AGENDA—ARCHITECTURE REVIEW BOARD MEETING

SUBJECT: Architecture Review Board Agenda, Item 3a
Residence, Vacant Lot, 7340 North Pierron Road, Robert and Dina Abercrombie.
Review and approve proposed residence to be built on vacant lot adjacent to the Milwaukee River.

To: Todd Stuebe – Director of the Community Development Department
From: Elias Vareldzis – Floodplain Administrator
Date: 3/12/2021
Re: 7340 N. Pierron Road – Proposed Single-Family Residence with Attached Garage

PLAT OF SURVEY

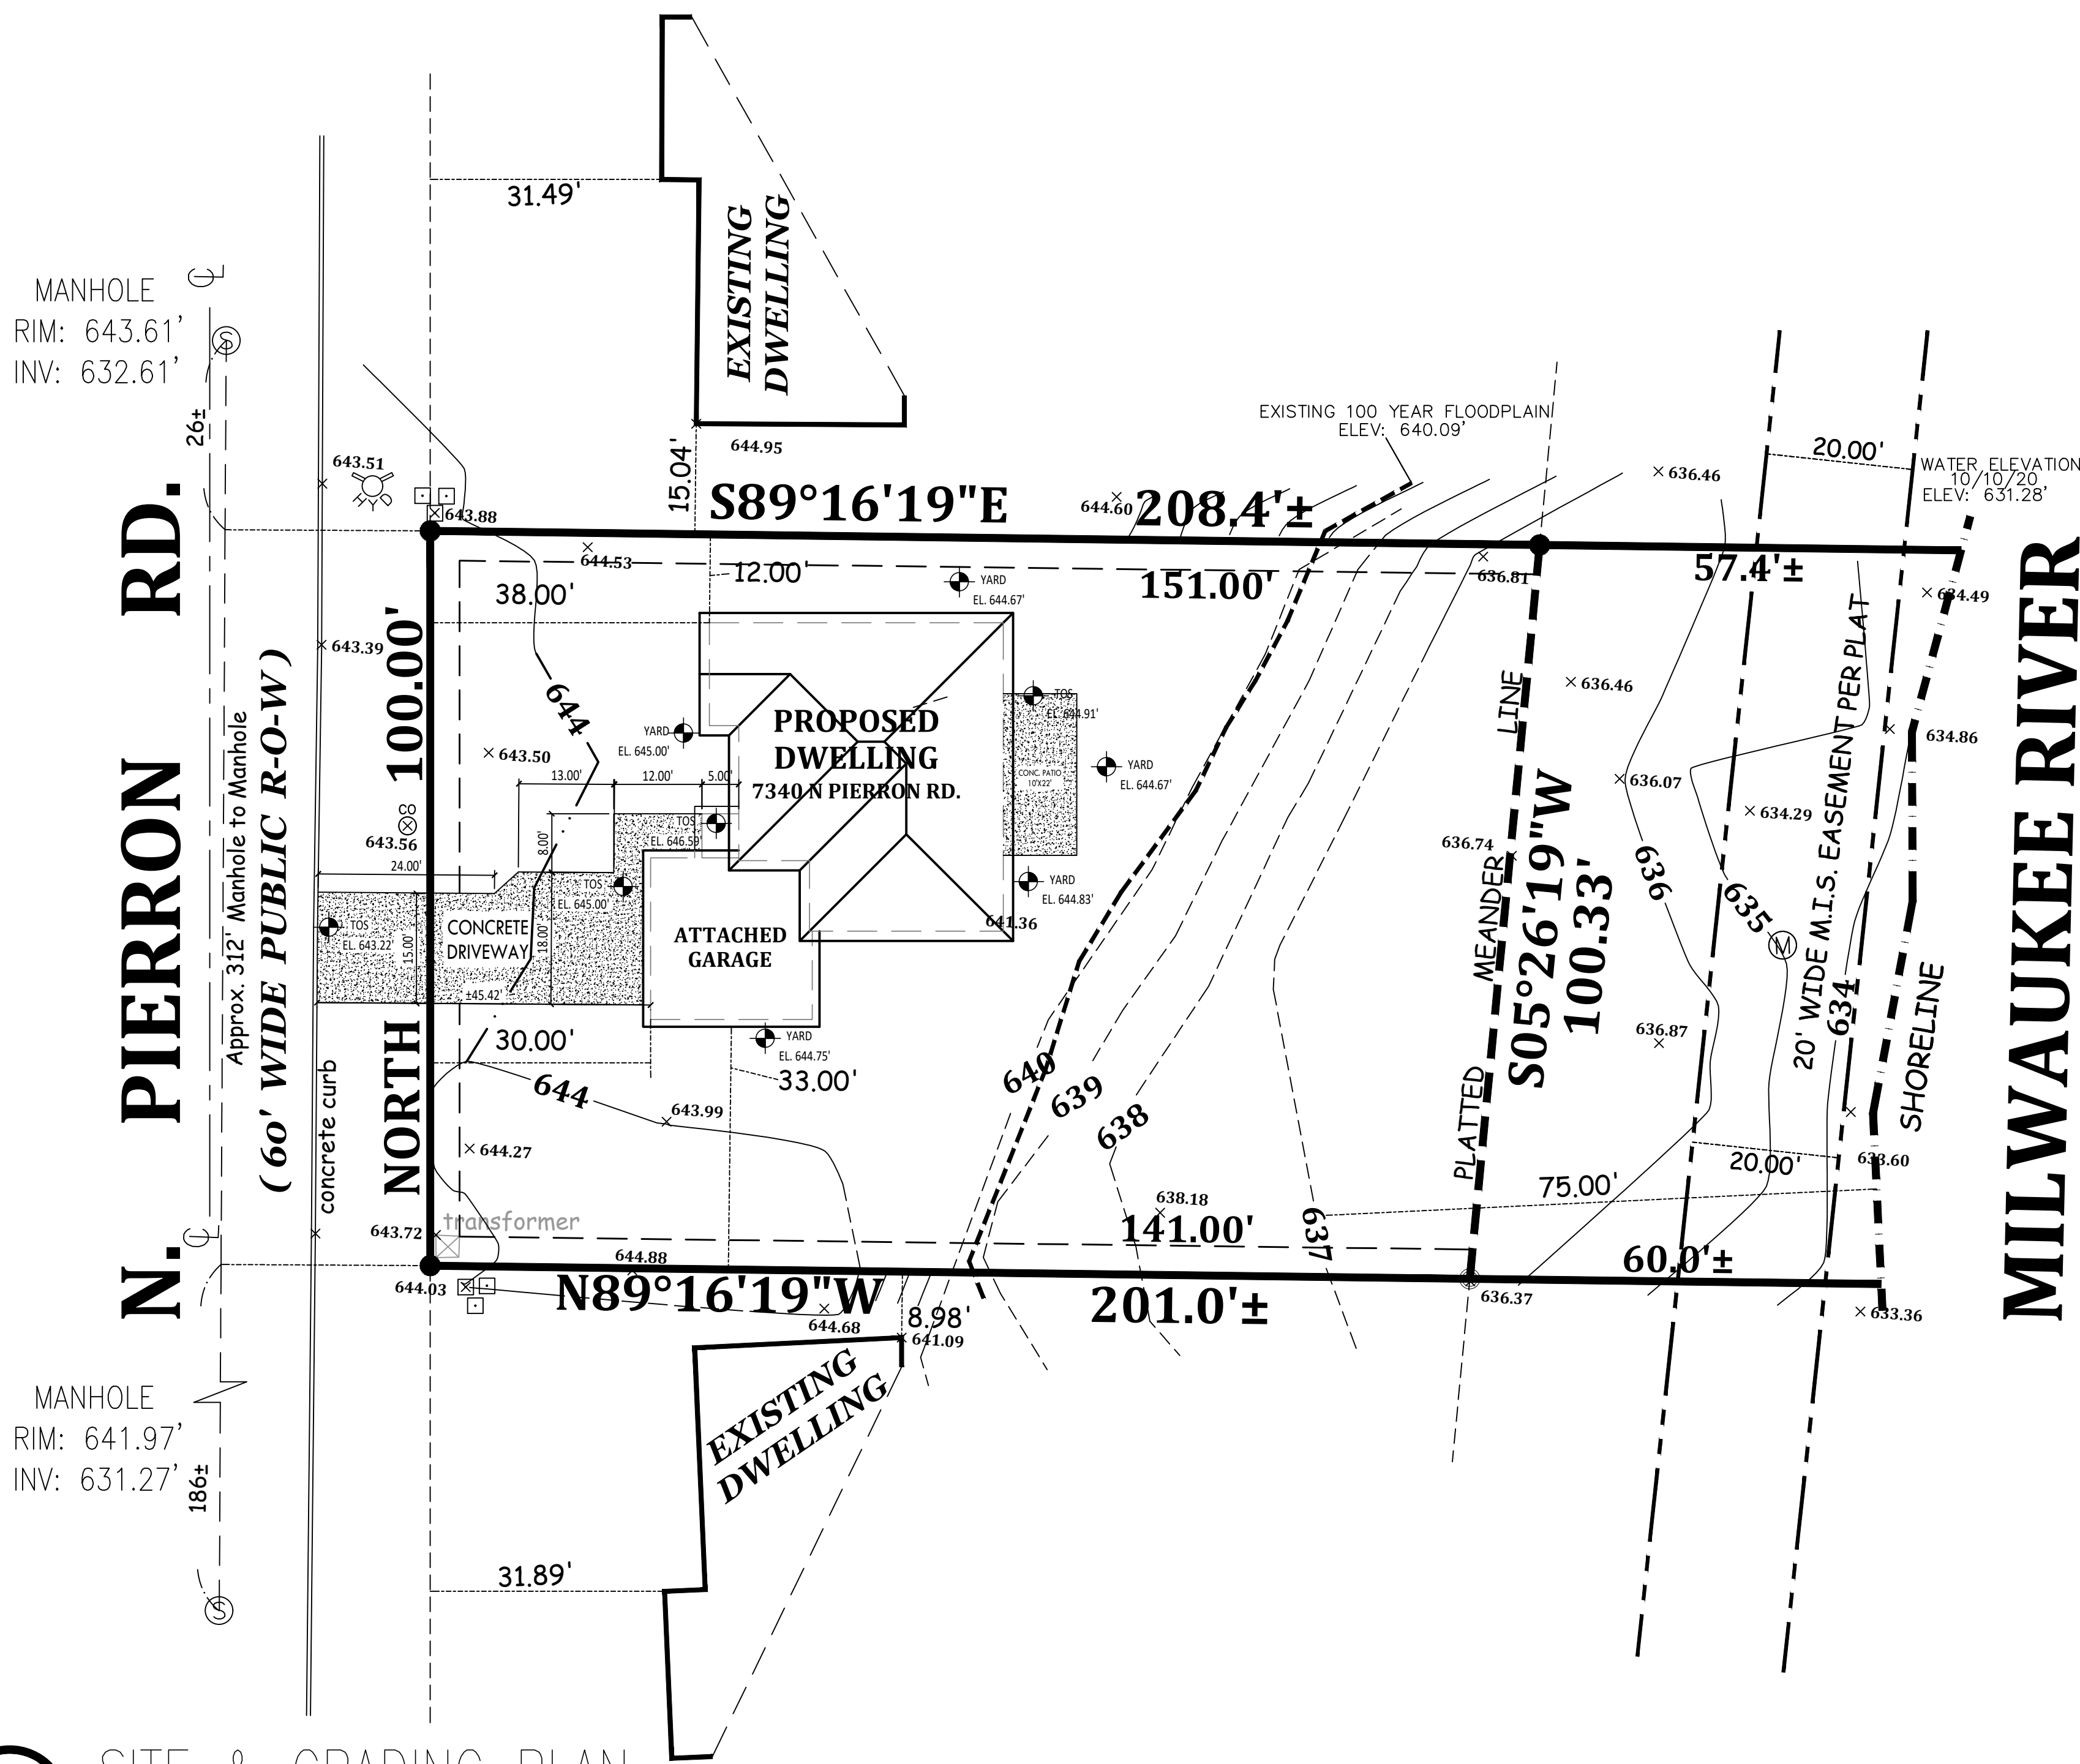
Additional documentation is required to satisfy Floodplain review of the project. There are discrepancies between the Base Flood Elevation of the 100-year Floodplain indicated on FEMA's NFIP maps and the value given on the applicant's Plat of Survey, which indicates a BFE of 640.09 feet. Additionally, the submitted Plat of Survey and Site Plan should include the locations of both the 100-year Floodplain boundary **and** the Floodway boundary for reference. The Plat of Survey must also be signed and sealed by a Registered Land Surveyor. If any proposed development changes infringe upon the 100-year Floodplain, Ordinance Sections 13.2.5 and portions of 13.2.7 would apply to the project. If applicable, a site plan indicating both current elevations as well as any proposed grading changes utilizing fill is required.

Currently, more information must be submitted prior to full review and acceptance of this plan. This project is not approved at this time.

Approve with any requirements established by the ARB, provide a Site Fill and Grading Plan, and per the requirements of the Floodplain Review Memoranda.
